RE: St. Lucie Units 1 and 2
Docket Nos. 50-335 and 50-389
Proposed License Amendment
EDG Risk Informed AOT Extension
Request for Additional Information Response

REQUEST FOR ADDITIONAL INFORMATION
RELATED TO THE AMENDMENT OF THE TECHNICAL SPECIFICATIONS
FOR THE EMERGENCY DIESEL GENERATORS
ST. LUCIE UNITS 1 AND 2
FLORIDA POWER AND LIGHT COMPANY
DOCKET NOS. 50-335 AND 50-389

FIGURE 1
Blackout Crosstie Bus Arrangement

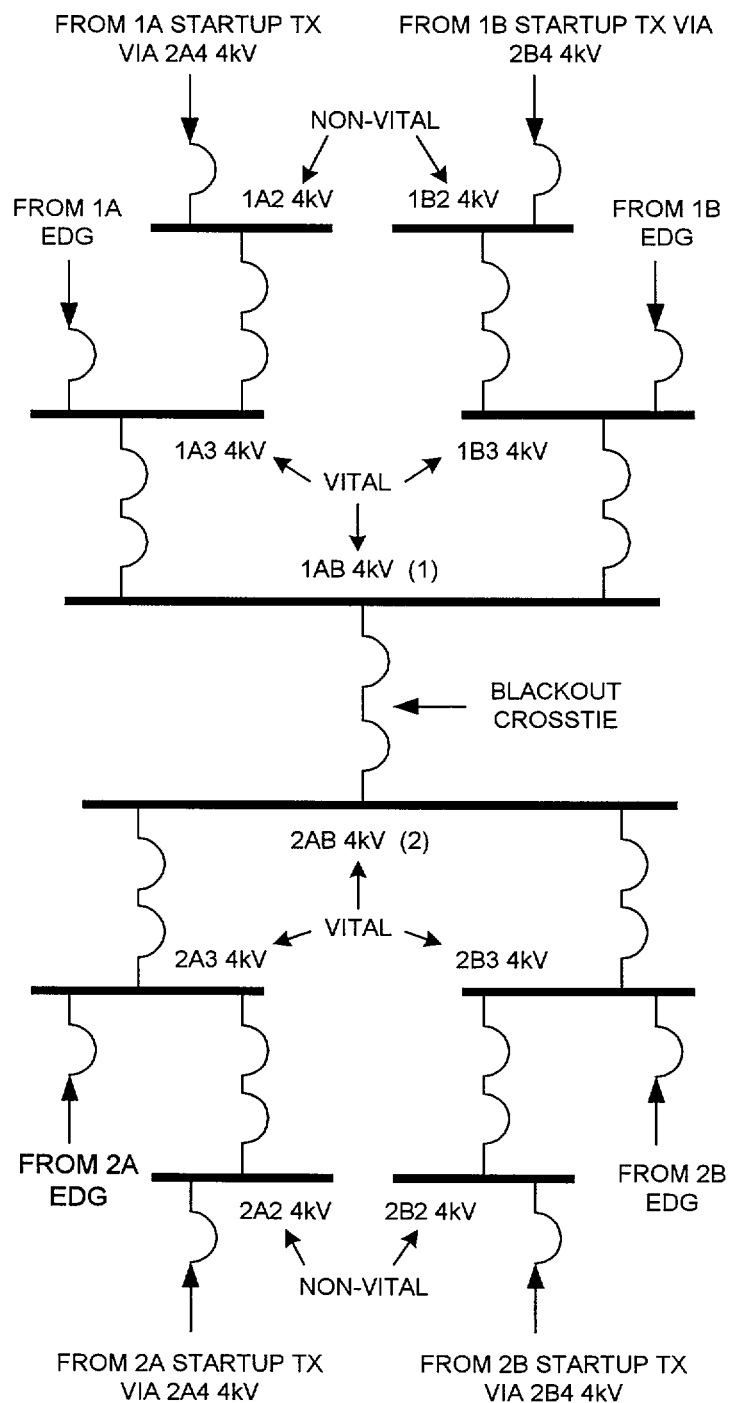
Is the crosstie recovery event failure probability (0.1) identical for both units? Explain why the asymmetry in design between the units was not captured.

The blackout crosstie recovery event probability is identical for both units. This event considers failures associated with both hardware (e.g., breaker failures) and the operator action. The design of the blackout crosstie and associated 4.16kV busses is symmetrical between the units. Figure 1 provides a simplified electrical diagram showing the blackout crosstie. The operator actions required are similar whether the crosstie is used to power a Unit 1 bus from Unit 2 or a Unit 2 bus from Unit 1. It is appropriate, therefore, to use the same blackout crosstie failure probability for both units.
